NTA Observations on the Proposed Scheme Submissions and CPO Objections

Belfield/Blackrock to City Centre Core Bus Corridor Scheme

National Transport Authority

September 2022

Figure 2.50: Facilities for Inbound Cyclists from Monkstown Road

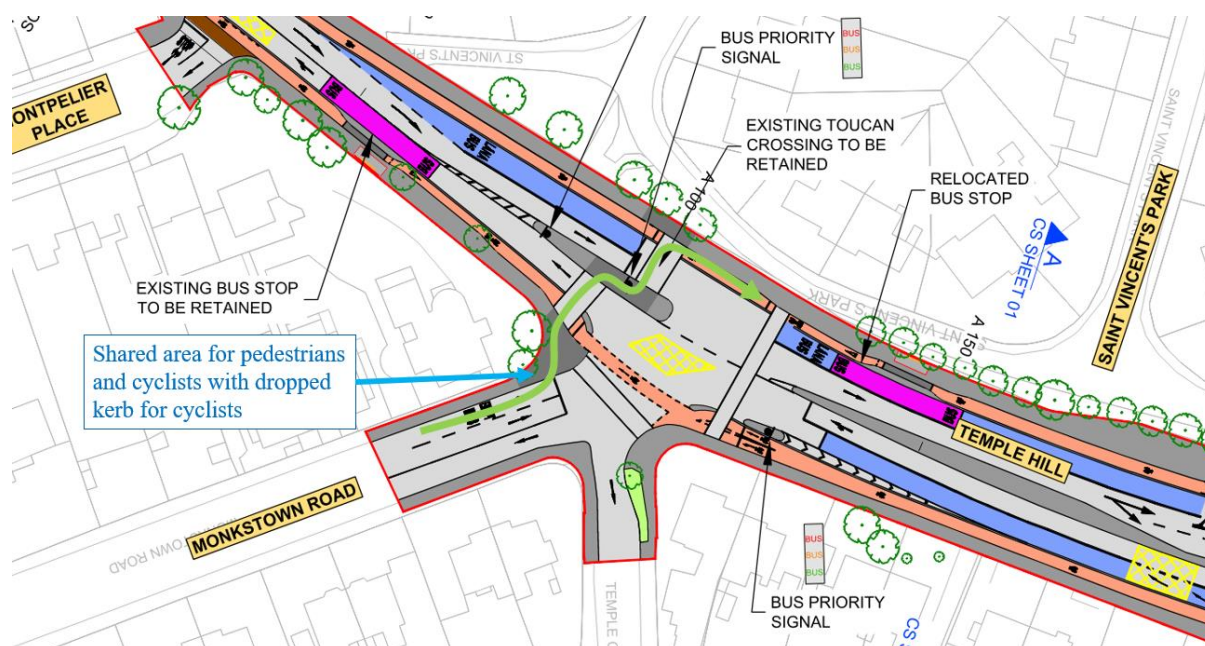
A design amendment has been suggested at the Monkstown Road approach to the Temple Hill junction to facilitate cyclists travelling inbound from Monkstown Road to Temple Hill (northbound). Cycle movement is accommodated via the proposed shared area at the corner of the junction to allow the inbound cyclist on Monkstown Road use the existing Toucan crossings (which will be retained) on the southern arm of the junction. This enables the inbound cyclists from Monkstown Road gain access to the inbound cycle track on Temple Hill as illustrated in Figure 2.50 below and outlined in section 4 (Junction Design and Modelling Results) of Appendix A6.3 Junction Design Report for the Temple Hill / Temple Crescent junction.

A fully protected junction was considered at this junction, however, the tall, large CCTV camera pole in the central median of the southern arm of the junction is a constraint to this layout, including a direct crossing to replace the existing staggered crossing, therefore, the Proposed Scheme will tie in to all existing facilities on all arms at the southern extents of the Proposed Scheme.
